**Planning Permit Application: TP- 2016-483**  
**488 – 494 La Trobe Street, West Melbourne**

**20 September 2016**

1. The purpose of this report is to advise the Future Melbourne Committee of an application for a planning permit seeking to construct a multi-storey building to be used as dwellings, ground floor retail premises (excluding hotel, tavern, adult sex bookshop, department store, supermarket and gambling premises) and an associated reduction in the car parking requirements.

**DELEGATED PLANNING APPLICATION REPORT**

DRAWING TITLE  
**SECTIONS**

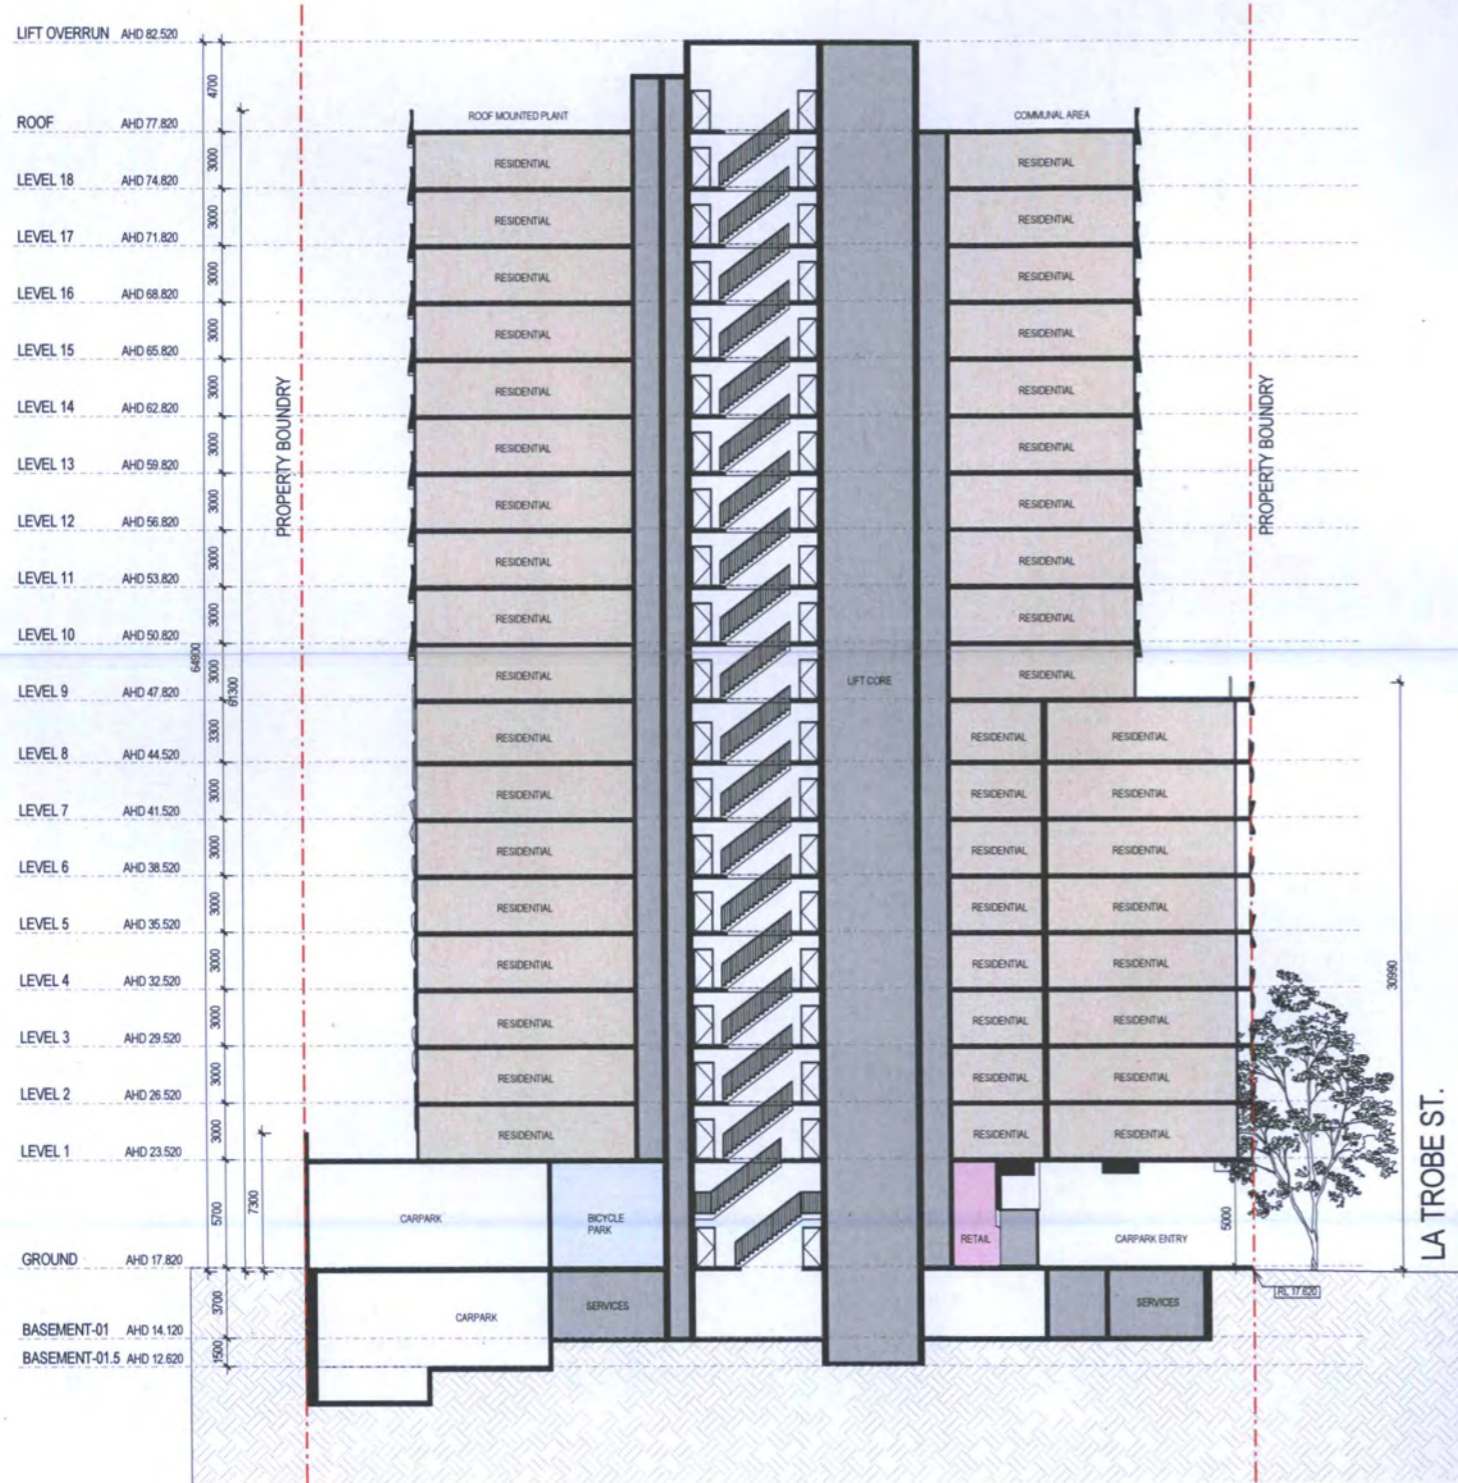
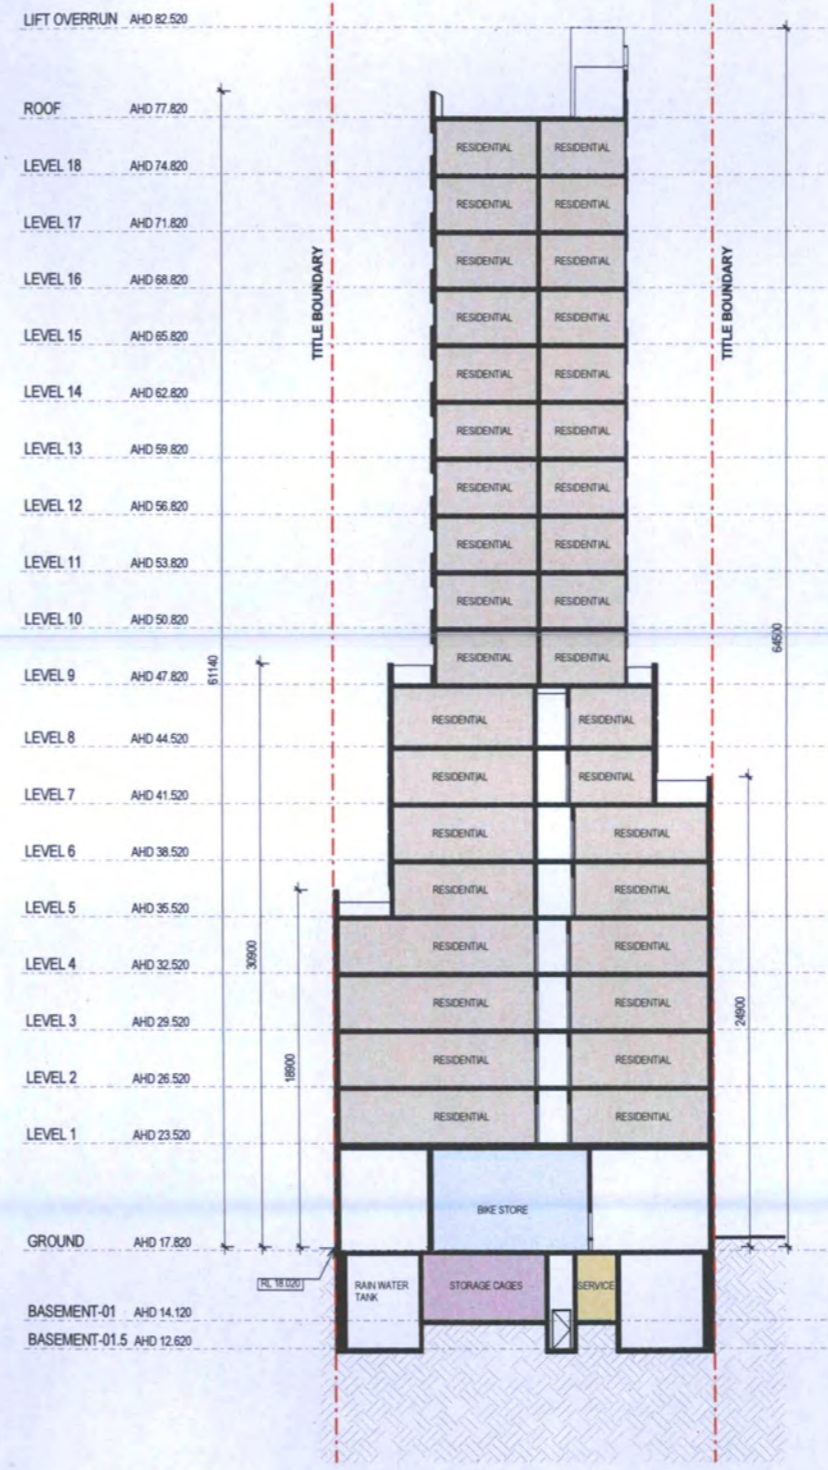
The proposal comprises of a 61m high (excluding the rooftop plant and equipment) building with a 30.9m high podium to La Trobe Street. . As depicted in the sectional diagrams (Section AA on drawing no. TP03.01 A), the 0.9m relates to the height of the balustrade on the roof terrace which is proposed above the podium on level 9. As such, the height of the street wall of the podium to La Trobe Street is 30m.

It is therefore recommended that the height of the podium be reduced by one level resulting in a 27m high podium. While this still exceeds the 16m podium height by an extra 11m, this is considered an appropriate contextual response in relation to building proportions and the visual bulk perceived from the streetscape and central city interface. This also addresses Council's Urban Design concerns in seeking a taller, more robust podium form on the site.
